**SUBJECT: Docket Nos. 50-361 and 50-362
Response to NRC Request for Information
Proposed Change Number (PCN)-548
Battery and DC Sources Upgrades and Cross-Tie
San Onofre Nuclear Generating Station, Units 2 and 3**

REQUEST FOR ADDITIONAL INFORMATION
SAN ONOFRE NUCLEAR GENERATING STATION, UNITS 2 AND 3
AMENDMENT REQUEST TO UPGRADE BATTERY AND DC SOURCES
INCLUDING A BATTERY CROSSTIE CAPABILITY WITH AN
EXTENDED BATTERY COMPLETION TIME
(TAC NOS. MD0300 AND MD0301)

Figure 1 – Float Voltage at the DC Bus 2D4 over a 10 Month History

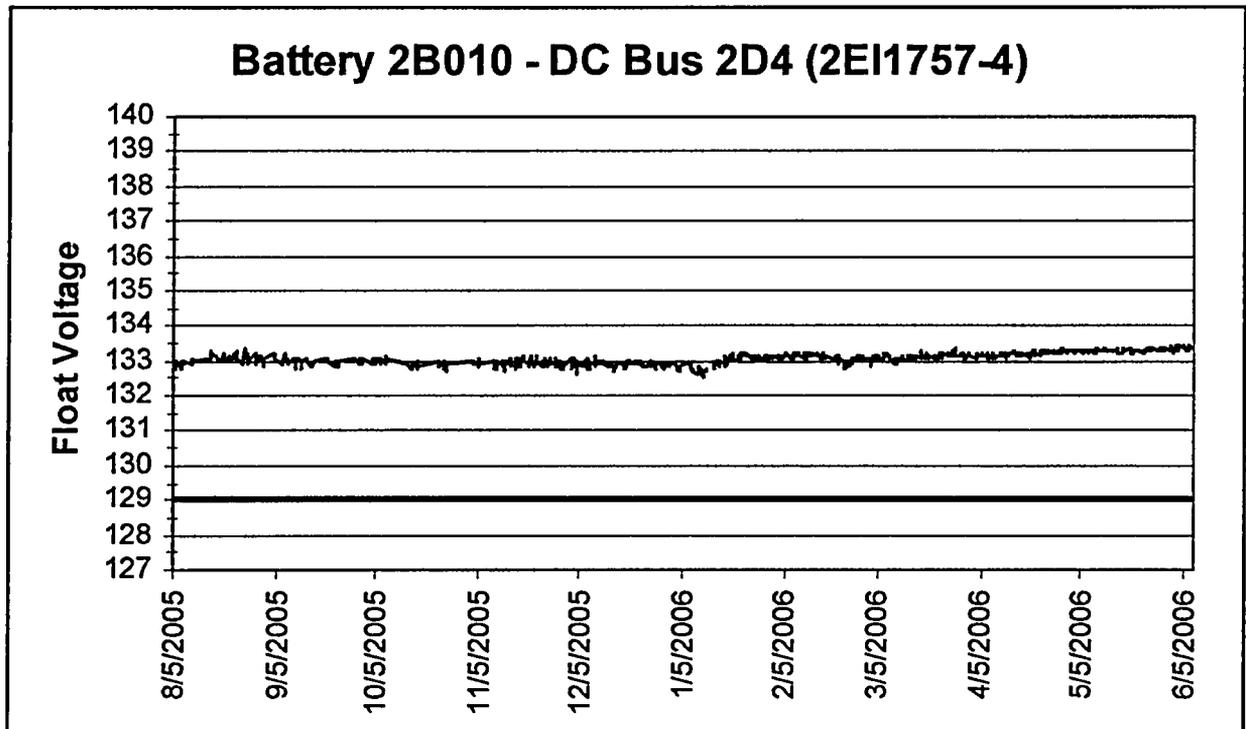
8. Reference 2 discusses additional technical specification (TS) changes including CT and surveillance test intervals (STIs) not related to the proposed risk-informed 30 day battery cross-tie CT. The RAI response qualitatively accepts the additional risk based on conformance to either TSTF-360 Revision 1, IEEE 450-2002, or with a specific risk assessment statement. Please discuss whether these additional STI, CT and TS changes were addressed in the modified SONGS risk estimate of the proposed 30 day battery crosstie CT.

Three surveillances (i.e: monitoring float voltage, float current and pilot cell voltage) are proposed to be performed every 31 days instead of every 7 days as are presently performed per the current TS. The acceptability of the longer interval is based on the vast accumulated experience by the nuclear industry at large and SONGS in particular. We have observed that the weekly data gathered during the past 20 years has remained virtually unchanged.

Figure 1 below demonstrates that the DC bus float voltage measured does not significantly change over time (refer to the 10 month sample period shown in Figure 1). The float voltage values measured weekly at the battery terminals were essentially unchanged. This observation is typical for all 8 Class 1E batteries installed at SONGS. The float voltage stayed between 131V-132V, equal or greater than 2 Volts above the minimum Operable Voltage of 129V.

Also, based on industry experience and specific SONGS observation, the cell internal resistance stays constant, therefore float current of a battery and the measured pilot cell voltage, due to the constant applied float voltage, would remain constant over weekly and monthly observation periods. Therefore, increasing interval between these surveillances from 7 days to 31 days will not likely affect the calculated risk.
